IMMEDIATE ACTION

NUMBER 164

May 16, 1958

MODEL AFFECTED: PA-24 Comanche

NOSE GEAR DOOR RETRACTION ROD	
SKETCH "A"	Service Bulletin 164
PIPER AIRCRAFT CORPORATION	
LOCK HAVEN, PENNSYLVANIA

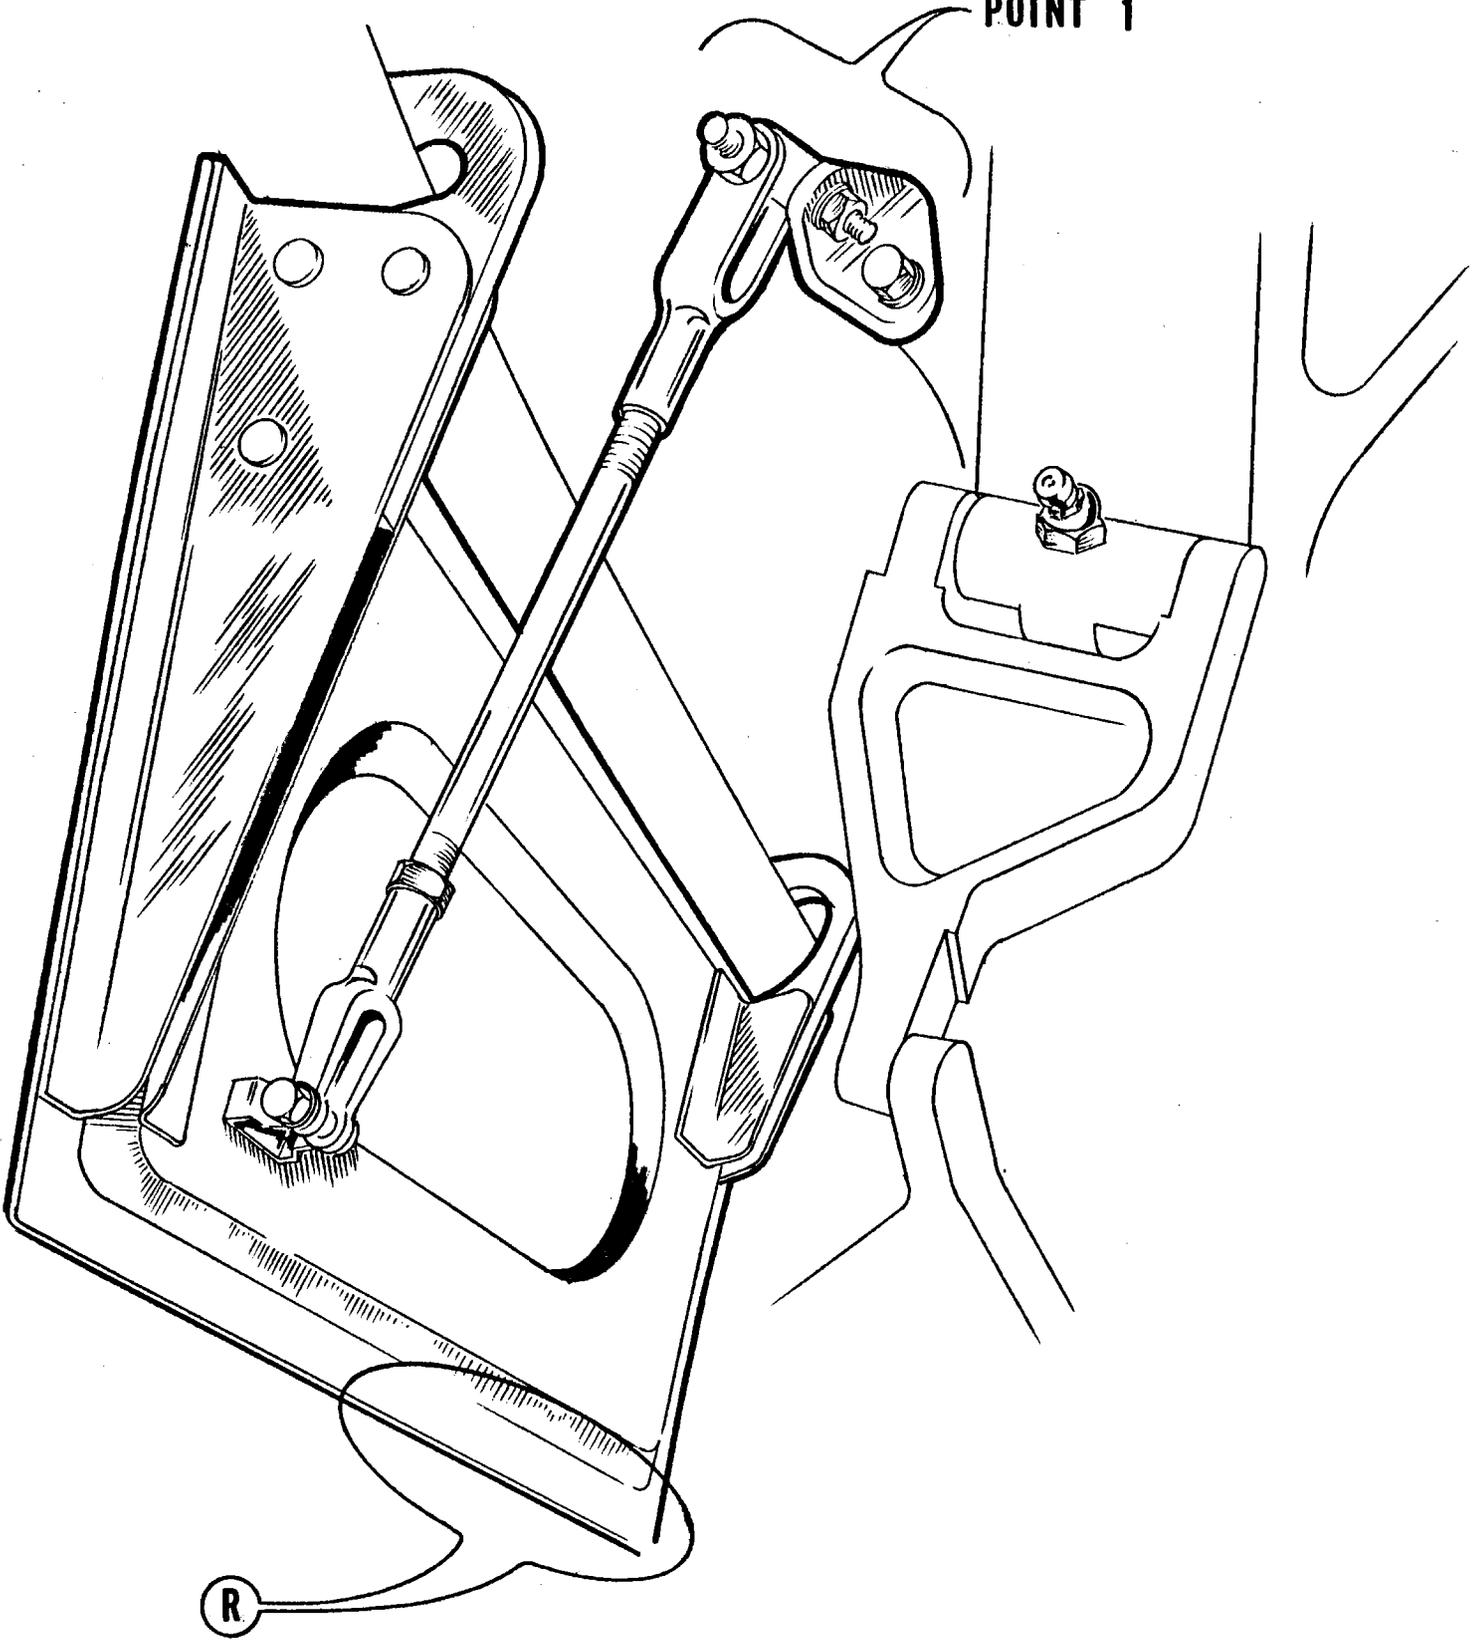
To preclude the possibility of damage to the nose gear door, it is recommended that the door retraction rod attachment on serials 24-1 to 24-76 inclusive be inspected and changed, if necessary, per Sketch "A" and instructions attached to this bulletin. The lock nut for the upper rod end fitting for the retraction rod must be removed on aircraft serials 24-1 to 24-106 inclusive.

1. Place aircraft on jacks and tail pedestal. (300 lbs. ballast on pedestal.)
2. Check eye bolt at upper end of retraction rod at point 1.
3. If eye bolt is not installed as shown, remove and reinstall per sketch.
4. Remove upper rod end fitting and lock nut.
5. Replace upper rod end fitting.
- *6. Disconnect lower end of rod from door assembly and back off upper rod end fitting approximately two (2) turns.
- *7. Reinstall lower end of rod to door temporarily and retract landing gear.
- *8. Keep adjusting the rod end fitting until the door closes flush with bottom cowl skin.
- *9. Tighten lock nut on bottom rod end fitting and complete installation of rod end to gear door.

If nose gear door rubs the gear strut when retracting gear, trim rear edge of door with tin snips in area "R".
